Permit Revision Submittal Requirements and Application

Project: OREGON SQUARE - 710 RENOVATION
Project Number: 20161921
Owner: AMERICAN ASSETS TRUST
Contractor: SWINERTON BUILDERS
Issued By: DUSTIN WHITE

ASI #: 09
Date: DEC 17, 2020

Permit Revision-1 to City to clarify non-rated plenum wall types and ceiling to correspond with construction and on-site inspections.

M11 NON-RATED GYPSUM C-H STUD WALL
UL: N/A NON-RATED, STC 40 TEST# NGC2001005

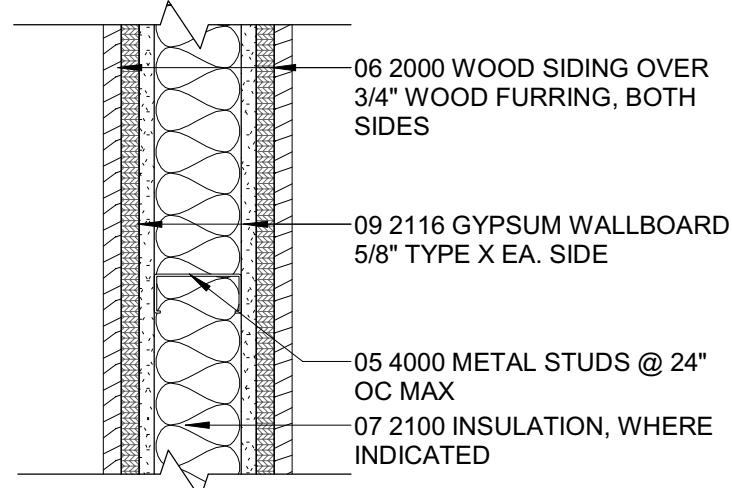
A010	Add Non-rated wall type using C-H studs & shaftliner
A601	Revise N.R. wall types at plenum
A701	Remove 1 of (2) layers gyp at restrooms plenum ceiling as per RFI-0051
A702	Add partial Gyp Ceiling to correspond with plenum bounds; Remove 1 of (2) layers gyp at restrooms plenum ceiling as per RFI-0051
A901	Remove 1 of (2) layers gyp at restrooms plenum ceiling as per RFI-0051
